IMPACT GARAGE DOOR SHOP DRAWING

DOORS AND WINDOWS SHOP DRAWINGS FOR NEW SFR.

12700 ROLLING ROAD DR. PINECREST, FL. 33156

GD-100

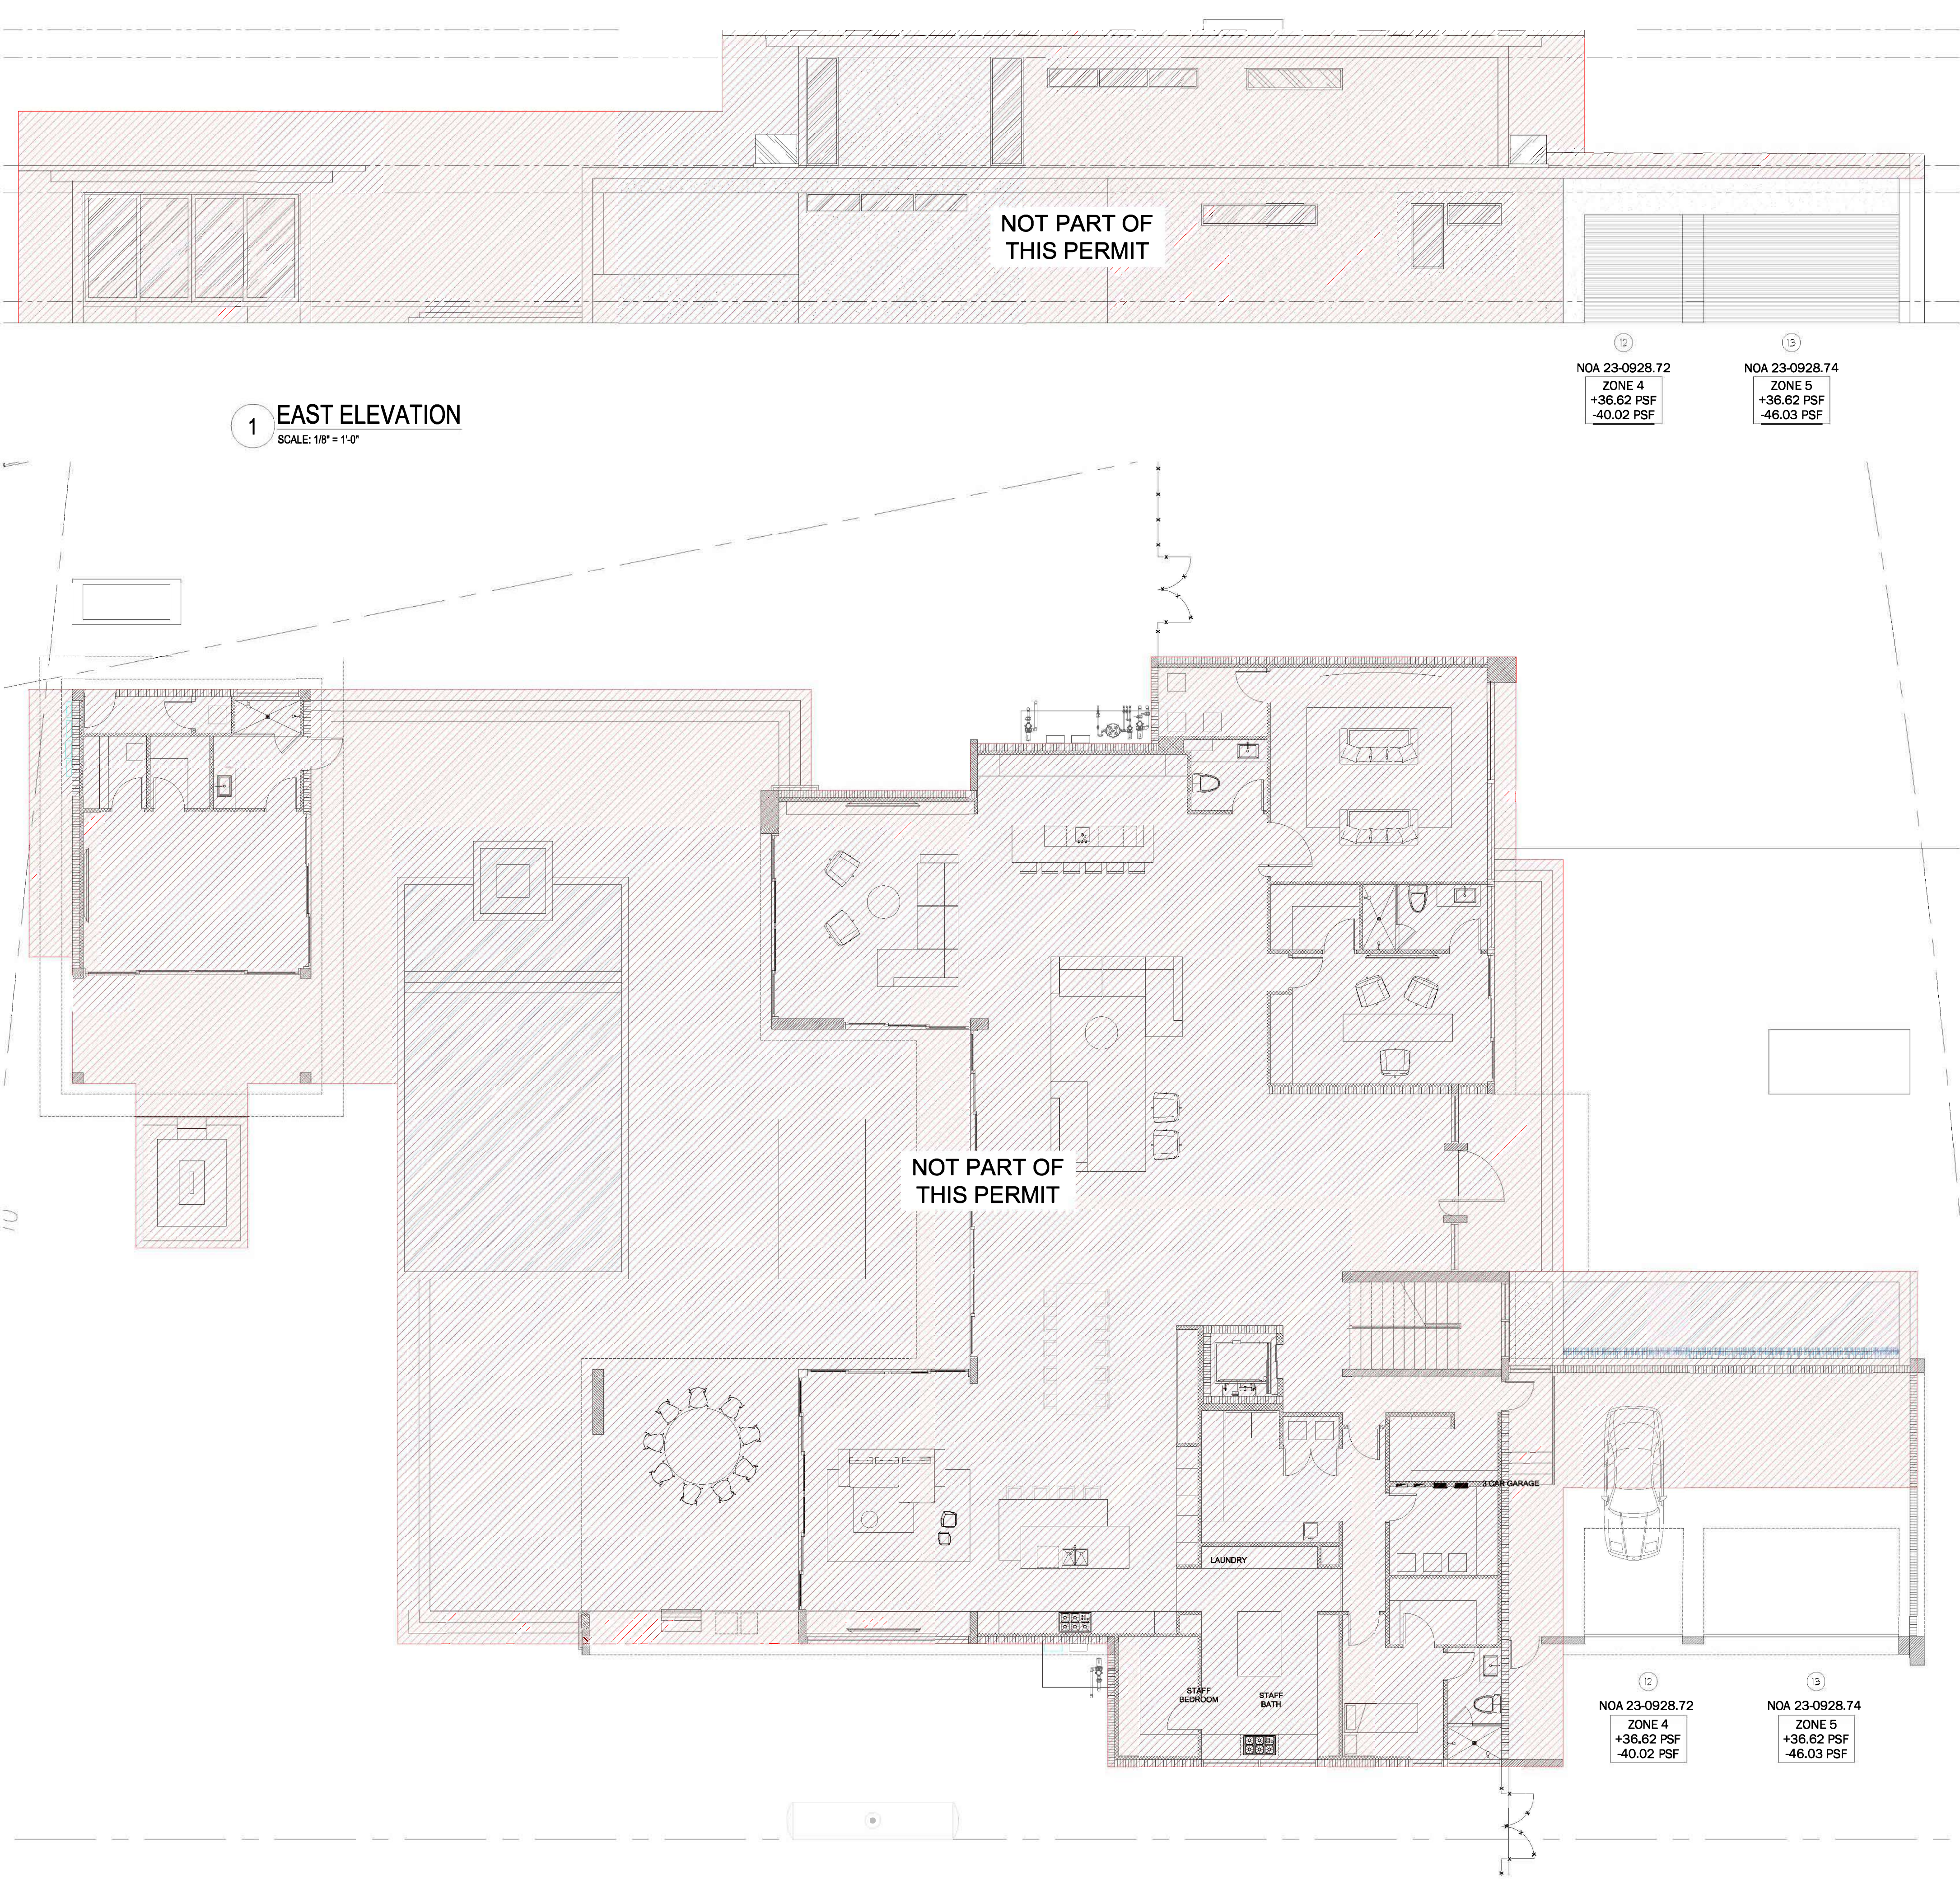
☒ APPROVED FOR CONFORMANCE WITH DESIGN CONCEPT
